## DEVELOPMENT APPLICATION ASSESSMENT REPORT

<b>Application Number:</b>	DA2020/1148
----------------------------	-------------

<b>Responsible Officer:</b>	Thomas Prosser
<b>Land to be developed (Address):</b>	Lot 10 DP 5302, 28 Wyadra Avenue FRESHWATER NSW 2096
<b>Proposed Development:</b>	Alterations and additions to a dwelling house
<b>Zoning:</b>	Warringah LEP2011 - Land zoned R2 Low Density Residential
<b>Development Permissible:</b>	Yes
<b>Existing Use Rights:</b>	No
<b>Consent Authority:</b>	Northern Beaches Council
<b>Land and Environment Court Action:</b>	No
<b>Owner:</b>	Robert John Hallam
<b>Applicant:</b>	Robert John Hallam

Warringah Development Control Plan - B3 Side Boundary Envelope

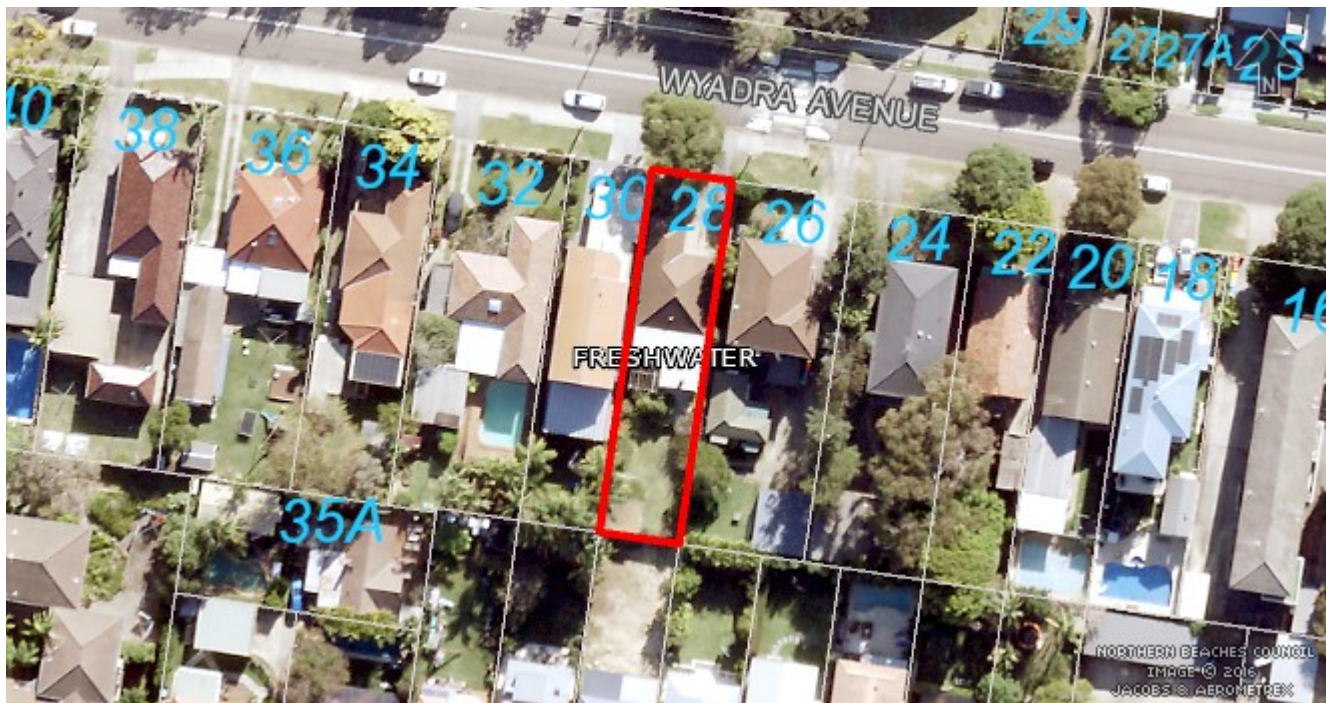
A minor section of the western elevation does not comply with the control for building envelope. This is at a location where the skillion style roof rises to its highest point (6m).

The side boundary envelope non-compliance will not result in a building that would be visually dominant in the area by virtue of bulk and height. The proposal is for a one storey extension with a roof style that follows the topography of the land to reduce presentation of height and bulk toward the rear of the site.

The proposal provides adequate physical separation to minimise amenity impact. In particular, the compliant building height, lack of new windows in the side elevation, and compliant rear setback ensures an appropriate situation for amenity to be maintained.

The proposal does not involve any significant excavation, and the rear extension has a rood which steps down with the topography of the land. This is an appropriate response to the topography of the site.

Having regard to the above assessment, it is concluded that the proposed development is consistent with the relevant objectives of WLEP 2011 / WDCP and the objectives specified in s1.3 of the Environmental Planning and Assessment Act, 1979. Accordingly, this assessment finds that the proposal is supported, in this particular circumstance.
